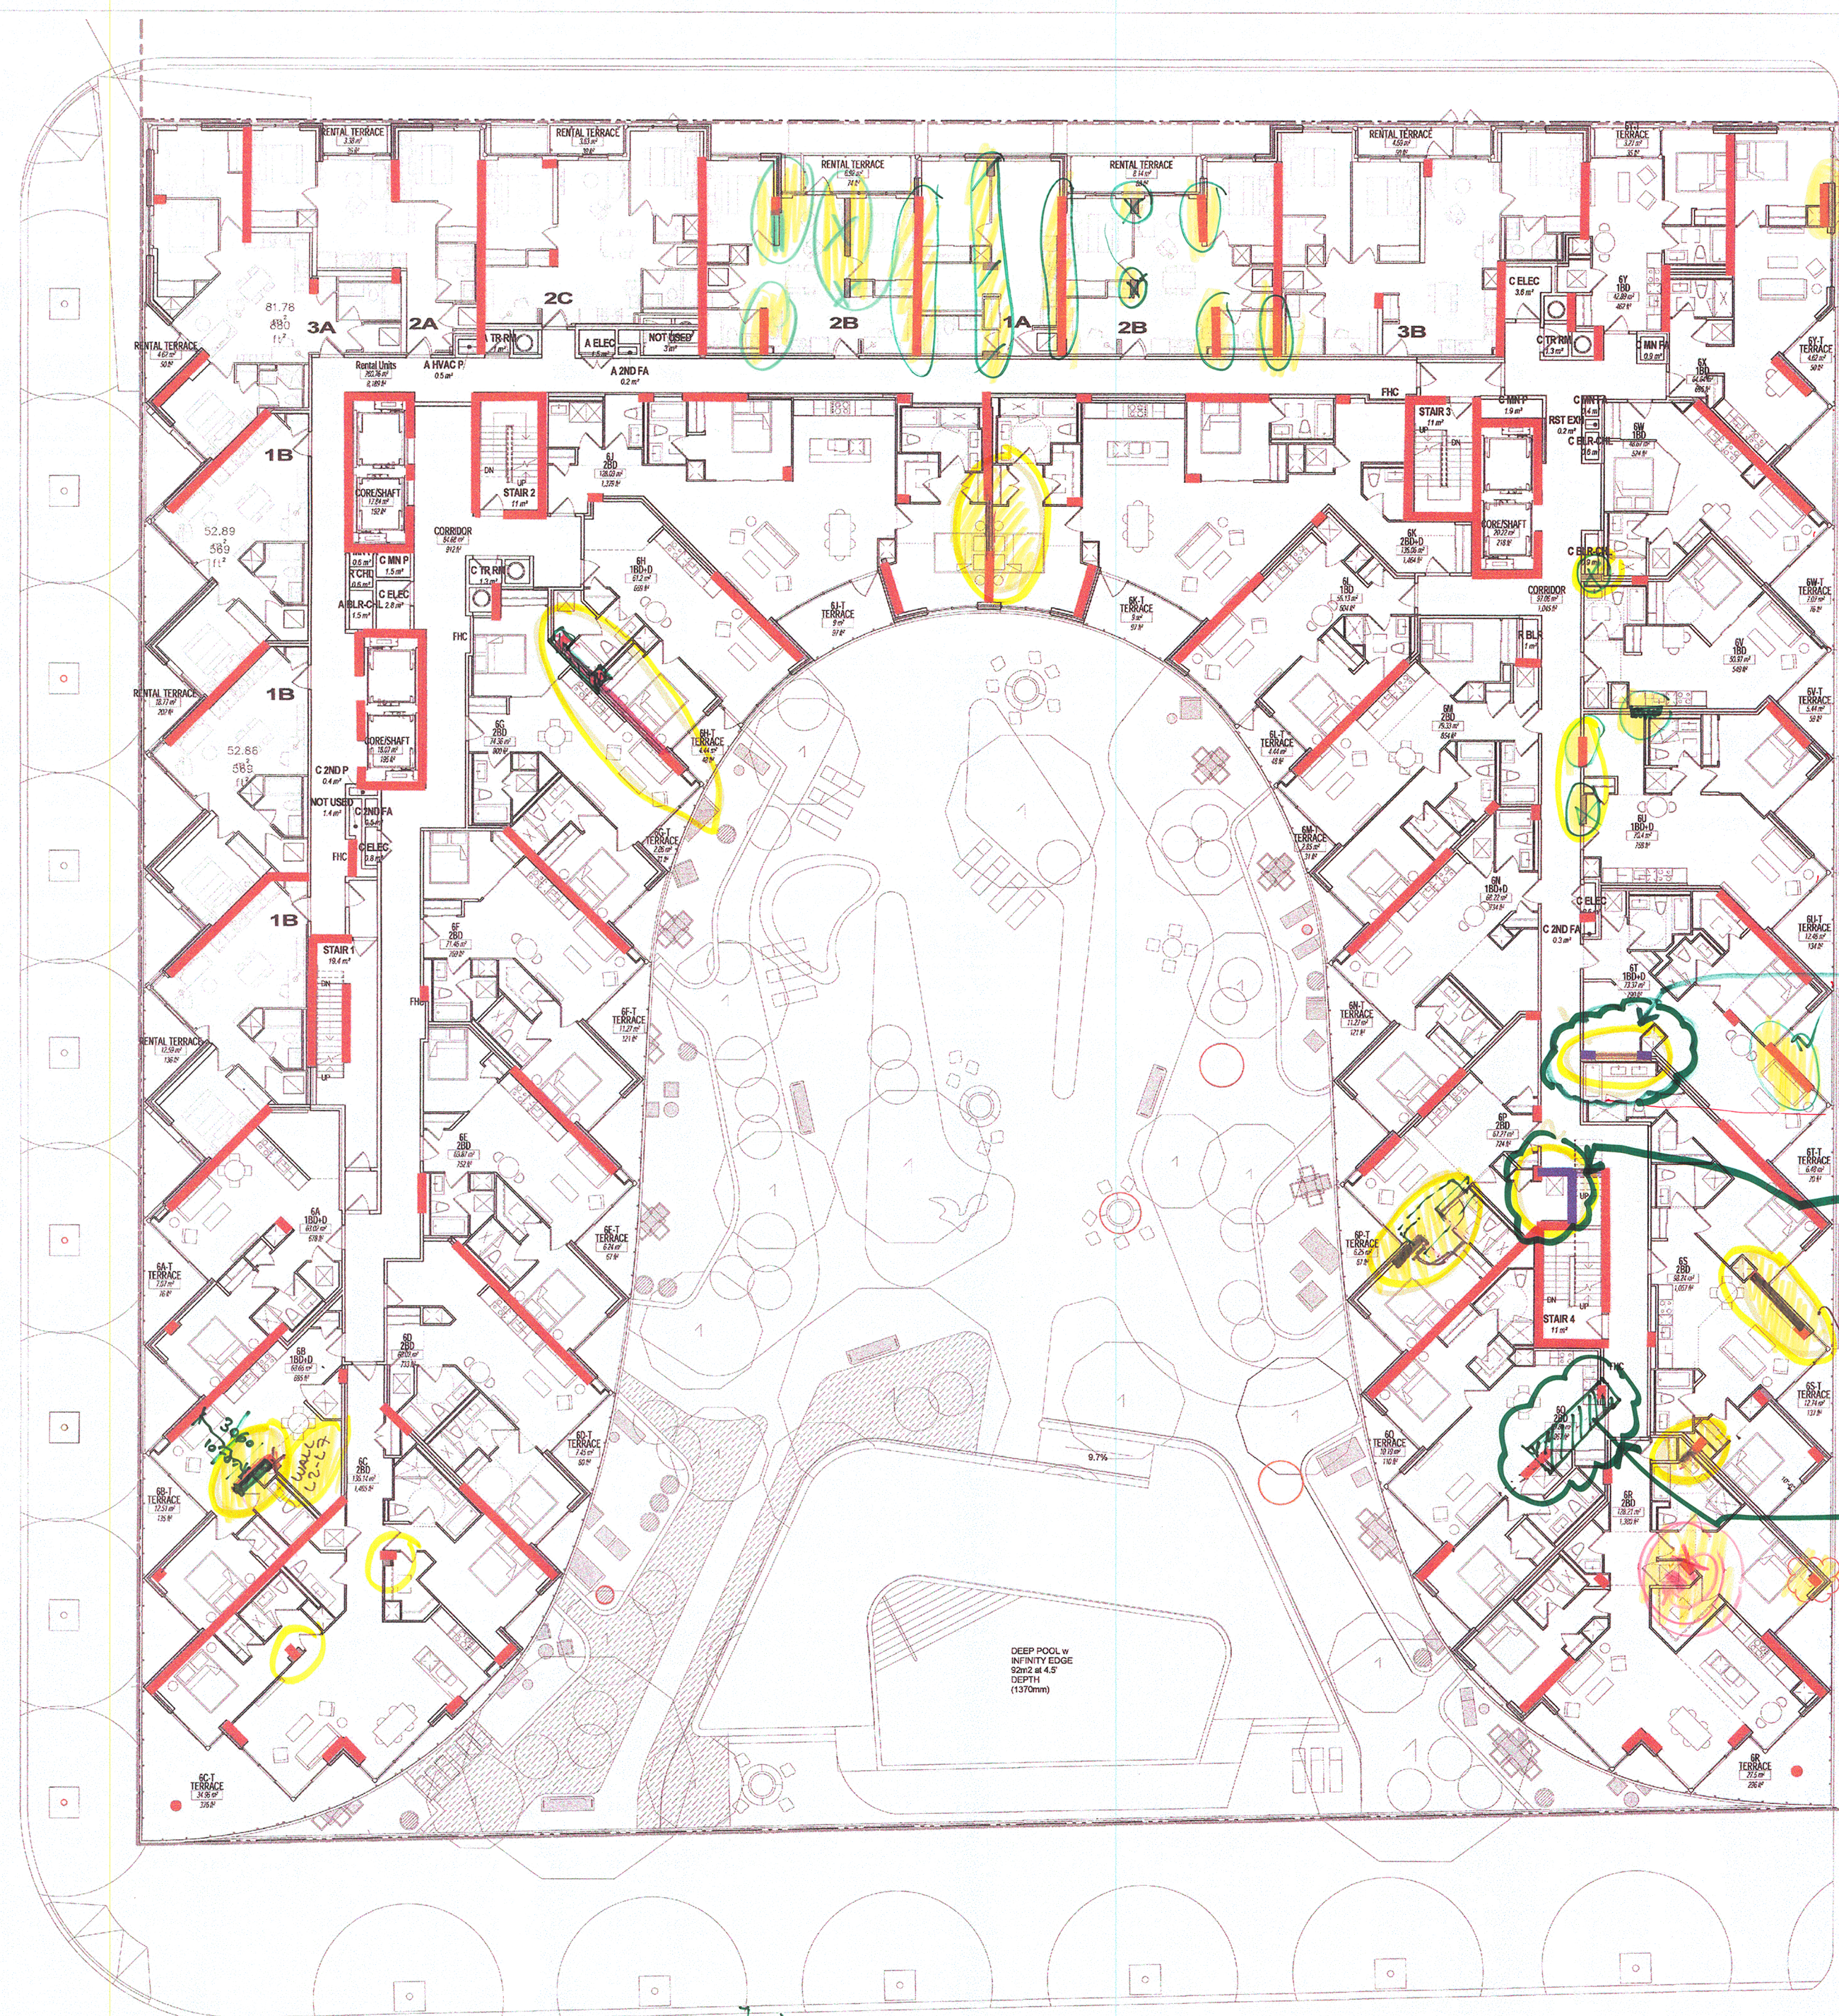
IS THERE A
TRANSFER SLAB
IN L3 SLAB?
(SHADED AREA)

DOES THIS COLUMN
STAY ON THIS LEVEL?

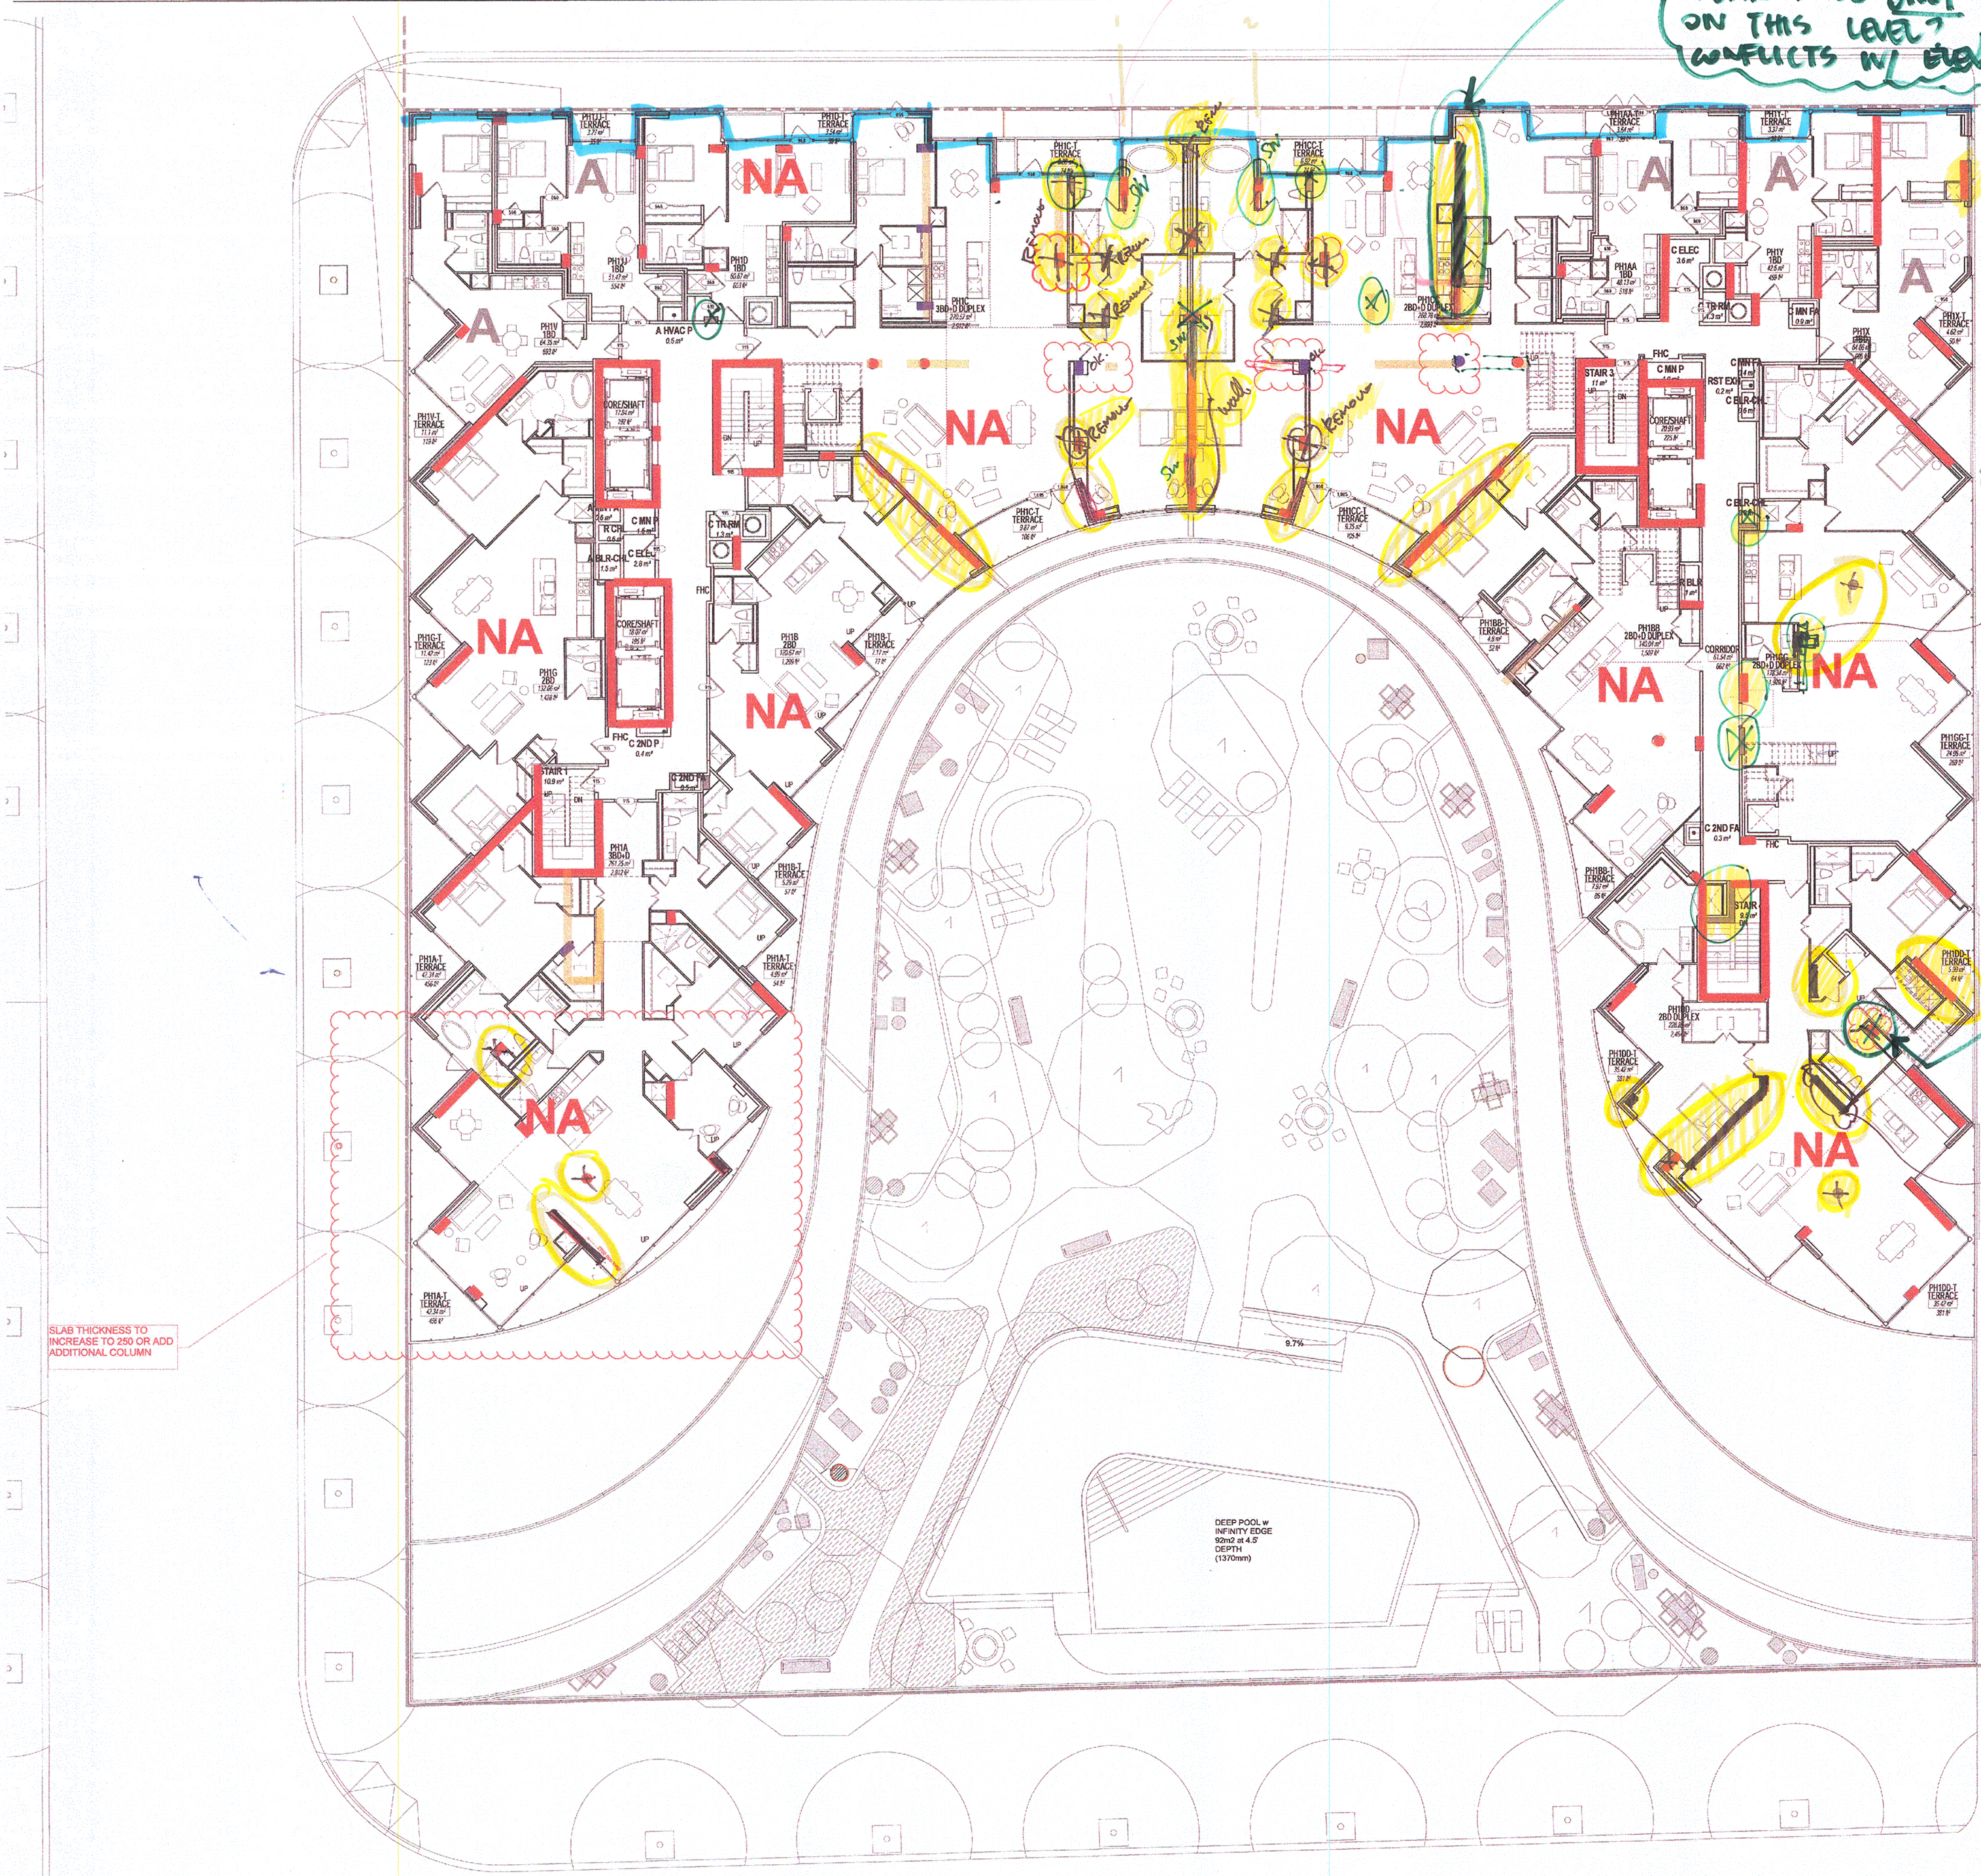
94.1 THIS PORTION OF SHEAR WALL NOT SUPPORTED FROM BELOW. TRIM IT OR DO TRANSFER SLAB IN L11 SLAB?

94.12 PLEASE CONFIRM TRANSFER SLAB IN SHADDED AREA IN L11 SLAB.

half below
half above

structural to review column layout

move envelope so that wall above is supported by column below

TRANS. SLAB IN L11

ADD WALL

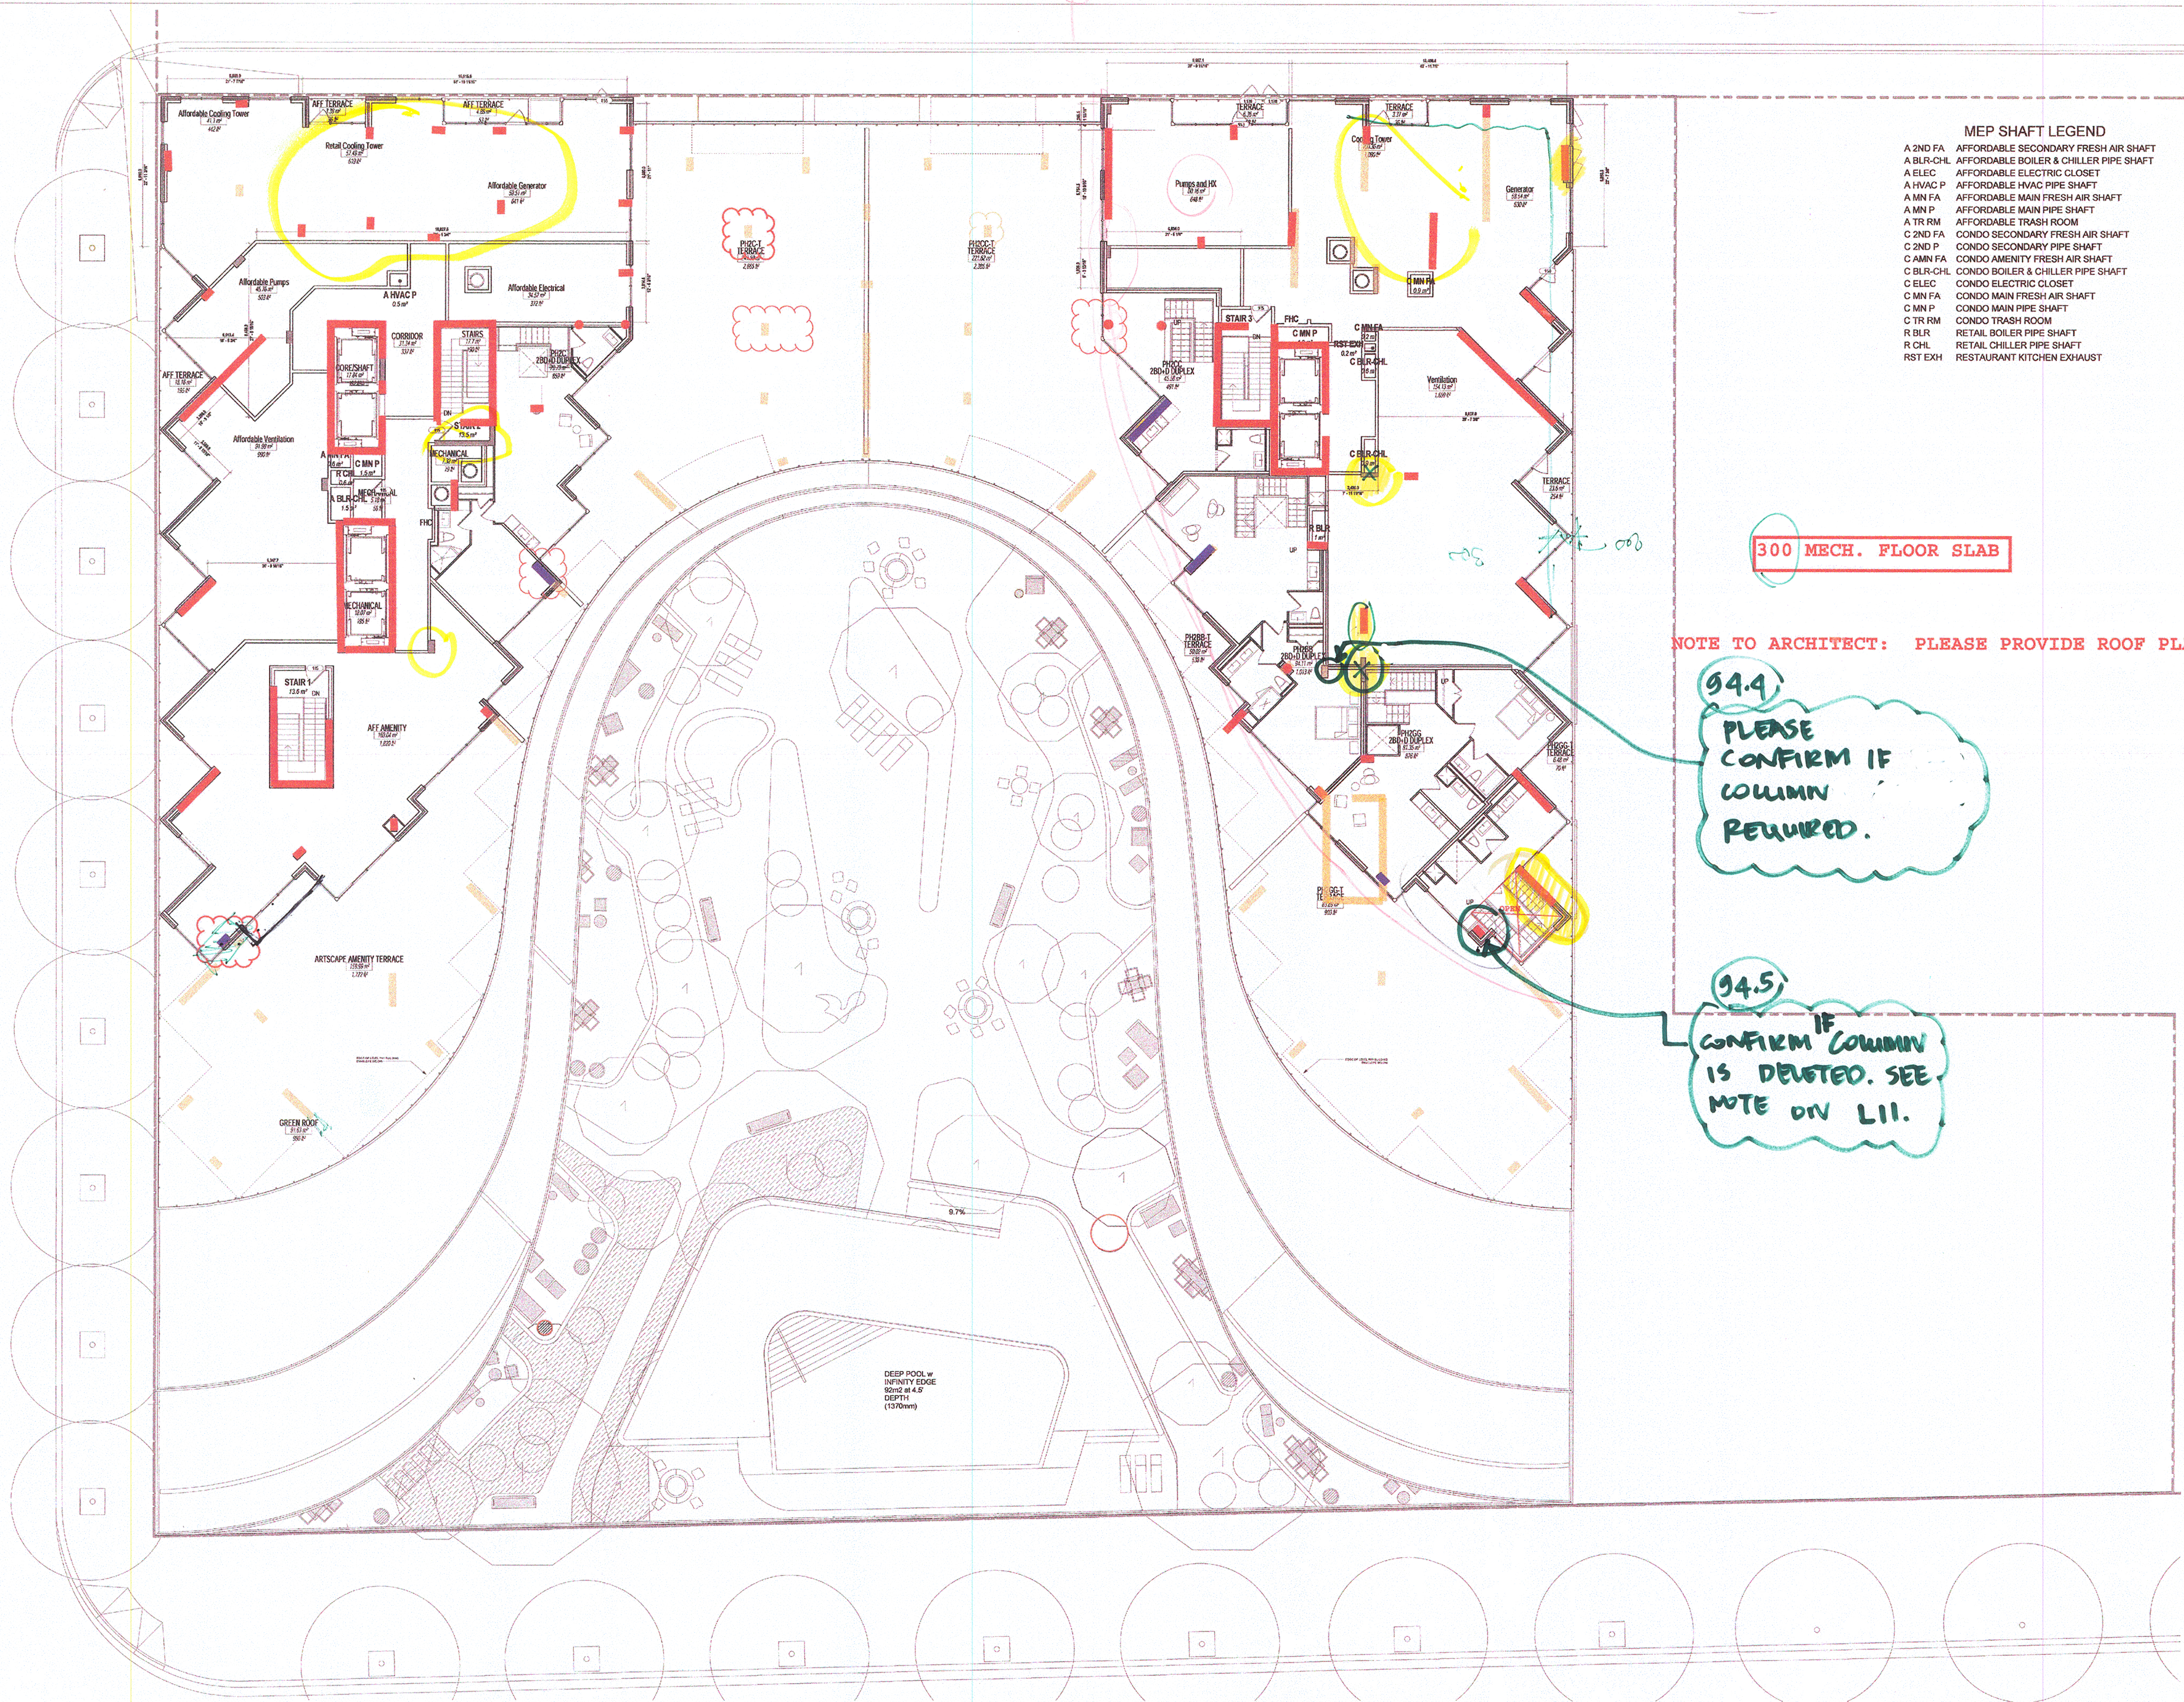
NOTE TO ARCHITECT: PLEASE PROVIDE ROOF PLAN

94.4
PLEASE
CONFIRM IF
COLUMN
REQUIRED.

94.5
CONFIRM IF
COLUMN
IS DELETED. SEE
NOTE ON L11.
